Project	IEEE 802.16 Broadband Wireless Access Working Group < http://ieee802.org/16 >
Title	Flexible Frequency Reuse Operation
Date Submitted	2004-07-08
Source(s)	Jeong-Heon Kim, Panyuh Joo, Seung Joo Maeng, Jaeho Jeon, Soon Young Yoon Samsung Electronics Co., Ltd. jeongheon.kim@samsung.com
Re:	Contribution supporting Sponsor ballot
Abstract	Frequency reuse factor of 1 and non-one frequency reuse factor support at the same time
Purpose	Adoption of suggested changes into P802.16e/D3
Notice	This document has been prepared to assist IEEE 802.16. It is offered as a basis for discussion and is not binding on the contributing individual(s) or organization(s). The material in this document is subject to change in form and content after further study. The contributor(s) reserve(s) the right to add, amend or withdraw material contained herein.
Release	The contributor grants a free, irrevocable license to the IEEE to incorporate material contained in this contribution, and any modifications thereof, in the creation of an IEEE Standards publication; to copyright in the IEEE's name any IEEE Standards publication even though it may include portions of this contribution; and at the IEEE's sole d

Figure 1 structure of downlink/uplink when type I scheme is applied

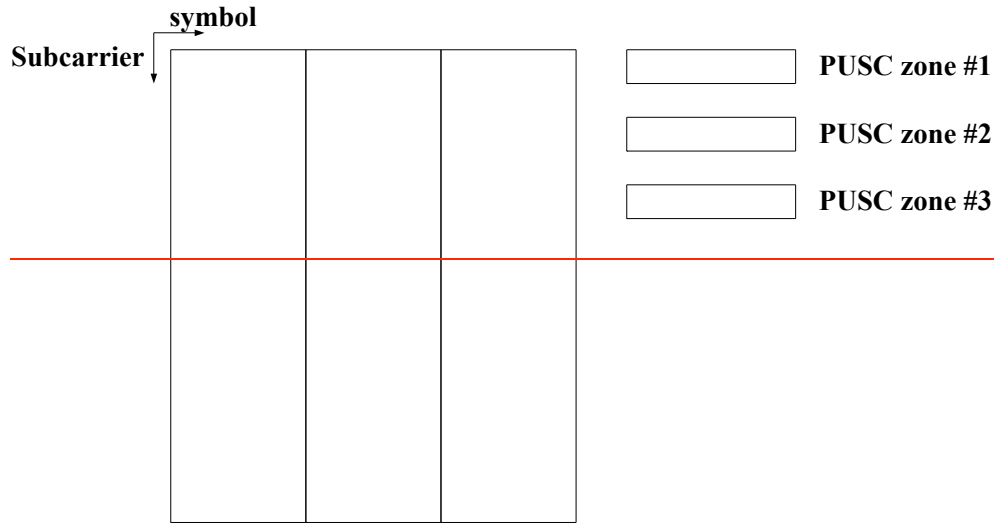
The current FUSC permutations can be candidates. In order for those FUSC permutations to be used in a partial usage manner some fraction of total symbols are partitioned into segments which can be called “PUSC zones” and each PUSC zone is used exclusively in each sector or each BS. Figure 1 shows an example of basic downlink or uplink structure when the above scheme is applied.

Subcarrier allocation for PUSC type I is depicted in Figure 1. Each PUSC zone is allocated a disjoint set of symbols. In each PUSC zone, Subcarrier allocation is the same as optional FUSC in section 8.4.6.1.2.3 and the permutation formula in section 8.4.6.1.2.3.1 shall be used.

Figure 2 Basic structure of downlink/uplink when type II scheme is applied

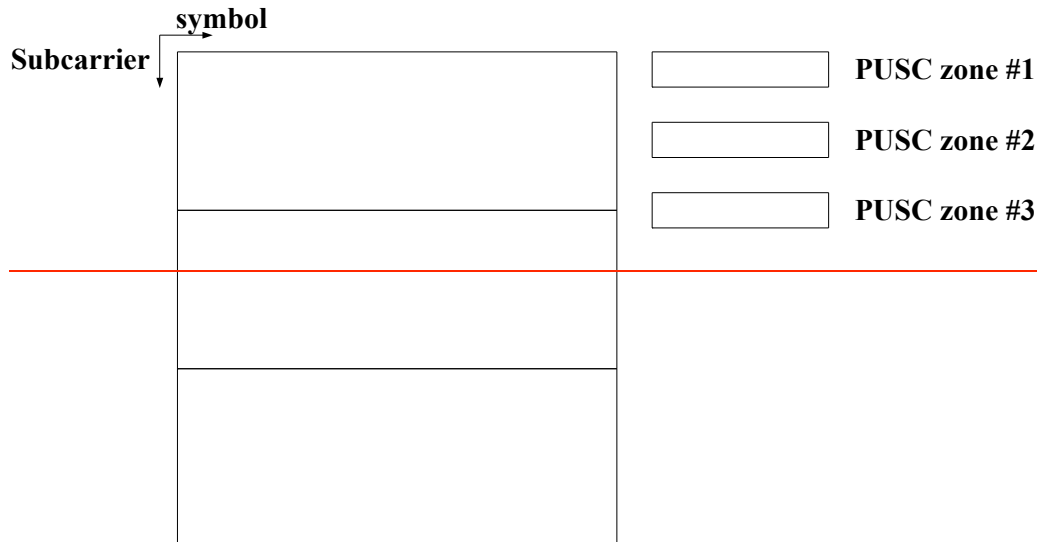
The method 1 divides the resources through time axis to provide partial usage mannered permutation zone. So called “PUSC zones” can be provided by dividing the resource through frequency axis which is the case in the currently supported schemes in 802.16 REVd/D5 and 802.16e/D3. The basic concept is depicted in Figure 2. In each PUSC zone, scattered carrier permutation scheme will be applied in order to provide frequency diversity.

Figure 3 Basic structure of downlink/uplink when a type III scheme is applied

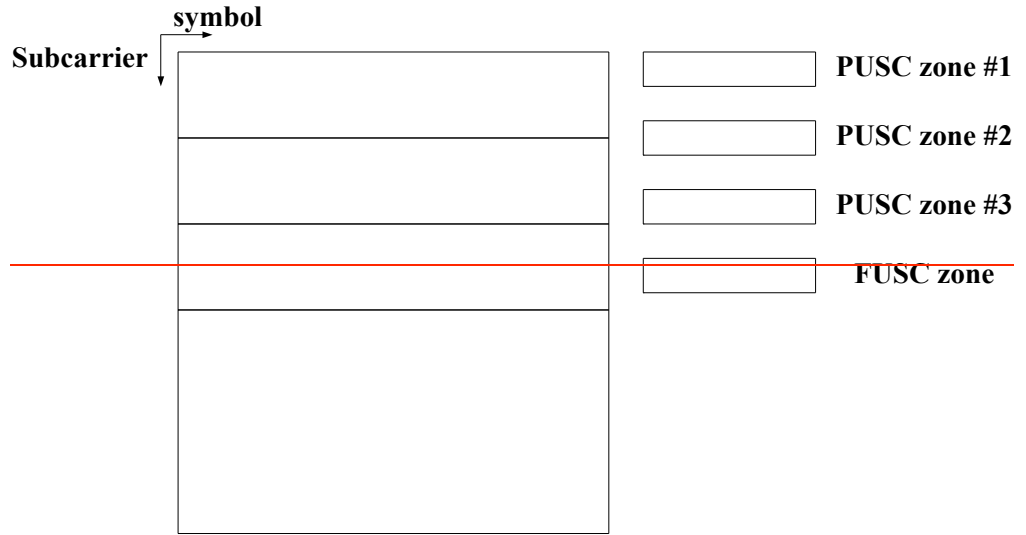
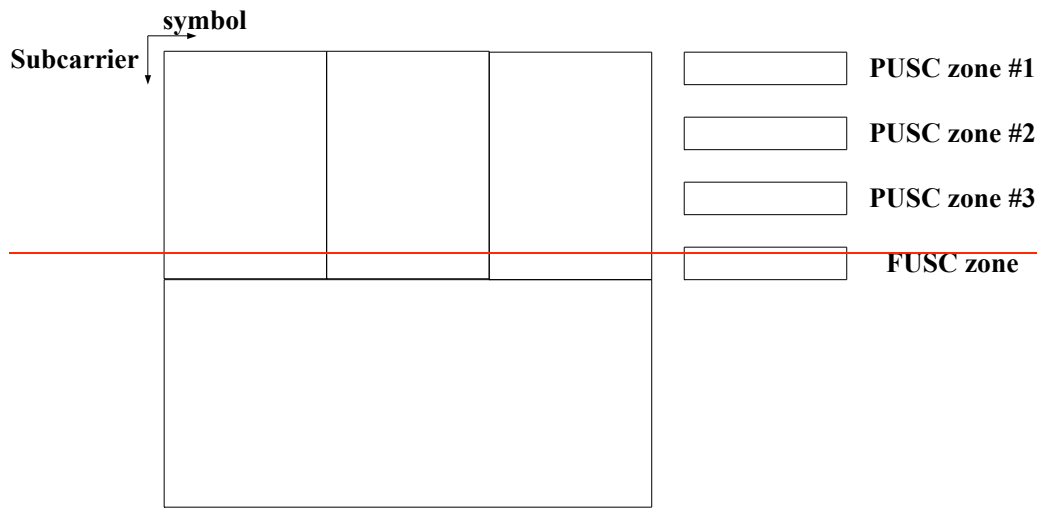
One more possibility is the mixed structure of method 1 and 2. That is, “PUSC zones” are constructed by dividing

resources through time and frequency axis. This scheme can give more flexibility to resource allocation.

Figure 4 aaa Subcarrier allocation for PUSC type II

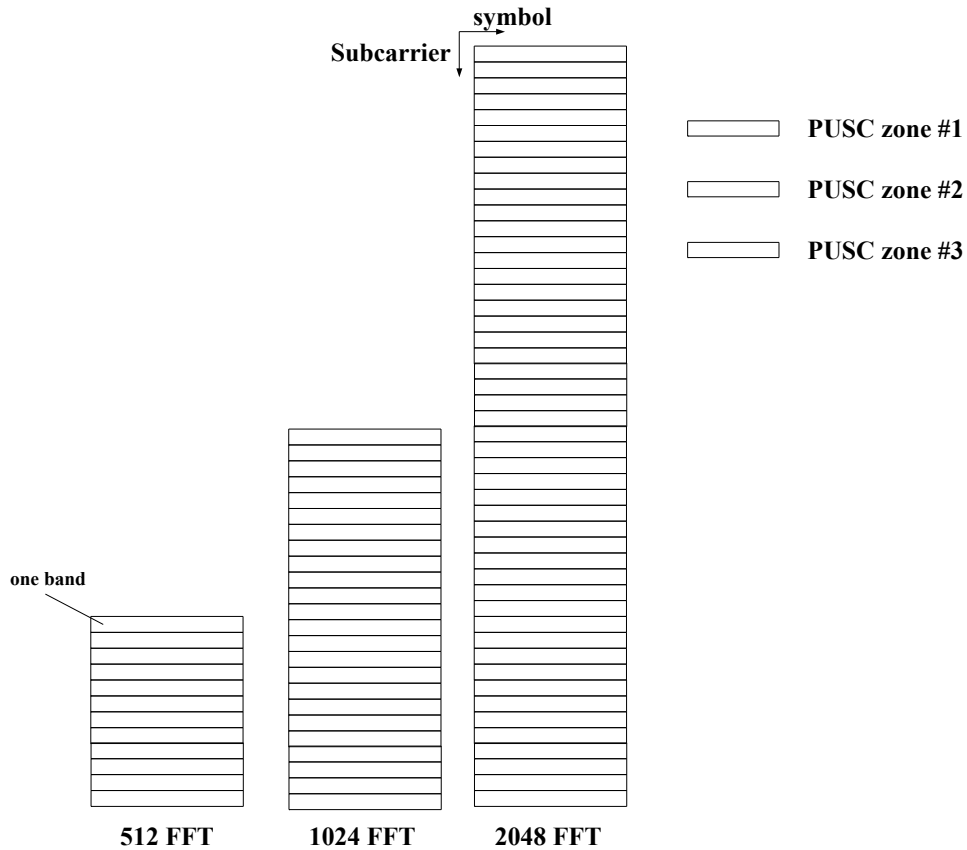
Subcarrier allocation for PUSC type II is depicted in Figure 4. A bunch of 9 contiguous subcarriers containing 1 pilot carrier and 8 data carriers is called a bin and 4 consecutive bins are called a band. Those bands are divided into three segments each of which is assigned to a PUSC zone.

For PUSC type II operation, total bands are partitioned into 3 segments and subchannel subcarrier allocation is done in each segment. The partition into 3 segments is shown in Figure 4. To allocate the diversity subchannels, data tones in 3 consecutive symbols in a segment are partitioned into 48 groups of contiguous data subcarriers. Each subchannel consists of one subcarrier from each of these groups. The exact partitioning into subchannels is according to the permutation formula in section 8.4.6.1.2.3.1. If FFT size is 512, then N_s is 8. If FFT size is 1024, then N_s is 16. If FFT size is 2048, then N_s is 32. The basic permutation sequences P_1 and P_2 are shown in Table 309a. The enumeration of the subcarriers in a segment within three symbols starts from the lowest numbered data subcarrier of the first symbol in a segment and goes to the next carriers. If it reaches the last carrier in the symbol in the segment, it goes to the lowest data carrier of the next symbol and so on.

Figure 5 subcarrier allocation for PUSC type III-A

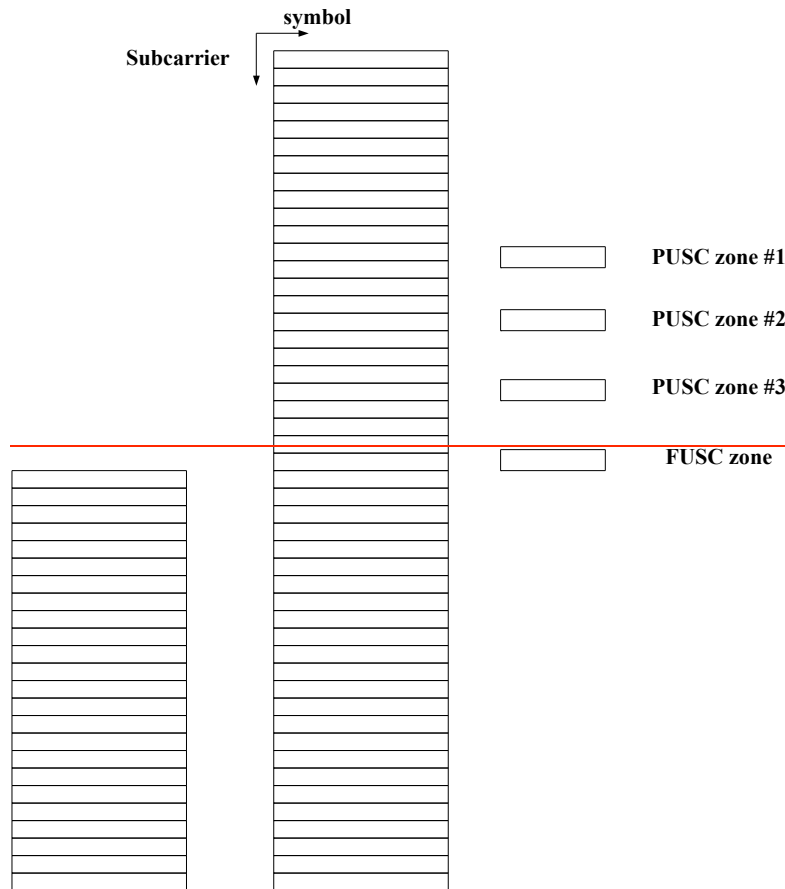
For 2048 FFT, N_{used} subcarriers are divided into 48 bands of contiguous subcarriers which are indexed from 0 to 47. Even numbered bands are used for FUSC and odd numbered bands are used for PUSC. 24 bands for PUSC are divided into 3 segments, which are used for different sectors respectively. The subcarrier allocation for FUSC + PUSC operation is described in Table 5. Similar subcarrier allocation for 1024 FFT is shown in Table 6.

Figure 6 Subcarrier allocation for PUSC type III-B in 1024 FFT

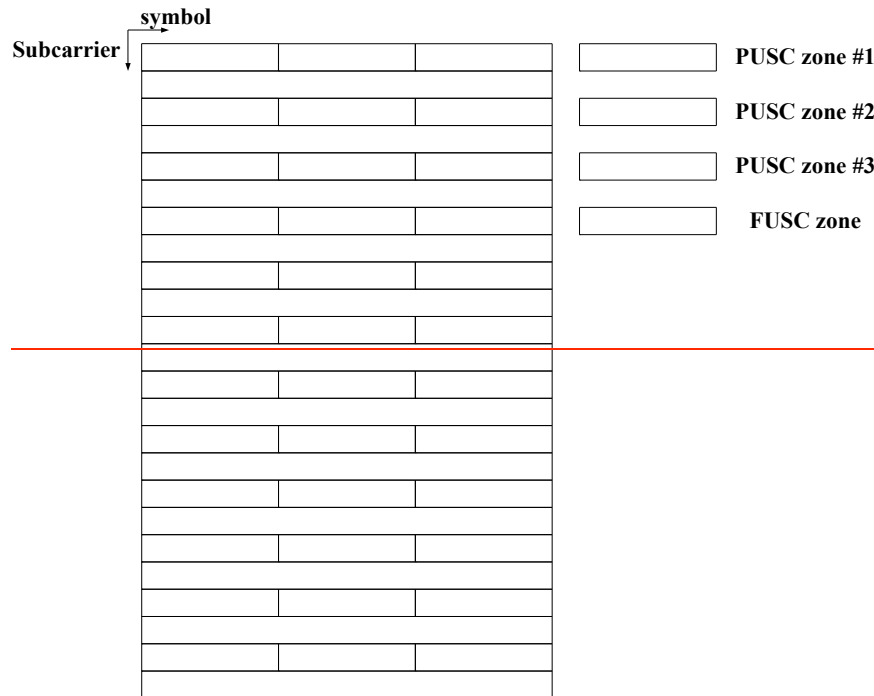
For 2048 FFT, N_{used} subcarriers are divided into 48 bands of contiguous subcarriers which are indexed from 0 to 47. Even numbered bands are used for FUSC zone and odd numbered bands are used for PUSC zone. The partition of subcarriers in three symbols is shown in Figure 6. The subcarrier allocation for PUSC type III-B operation is described in Table 11. Similar subcarrier allocation for 1024 FFT is shown in Table 12.
